# COLORADO DIVISION OF RECLAMATION, MINING AND SAFETY MINERALS PROGRAM INSPECTION REPORT

MINE NAME: Buena Vista Pit	MINE/PROSPECTING ID#: M-1977-196	MINERAL: Sand and gravel	COUNTY: Chaffee
INSPECTION TYPE: Monitoring	INSPECTOR(S): Dustin Czapla	INSP. DATE: May 22, 2013	INSP. TIME: 09:30
OPERATOR: Hard Rock Paving and Redi-Mix, Inc.	OPERATOR REPRESENTATIVE: None	TYPE OF OPERATION: 112c - Construction Regular Operation

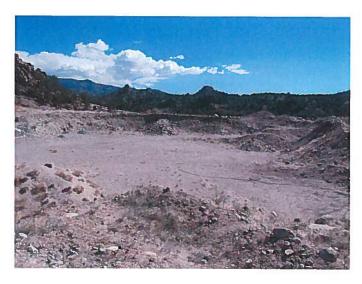
**PROBLEM/POSSIBLE VIOLATION:** Problem: Erosion gullies and ruts were observed on-site. This is a problem at this time for failure to protect the affected land from erosion pursuant to C.R.S. 34-32.5-116 (4) (j).

**CORRECTIVE ACTIONS:** The operator shall provide photo documentation to the Division verifying the erosion gullies and ruts in the north part of the site have been repaired, and that the site has been reconstructed and stabilized to minimize erosion damage by the corrective action date.
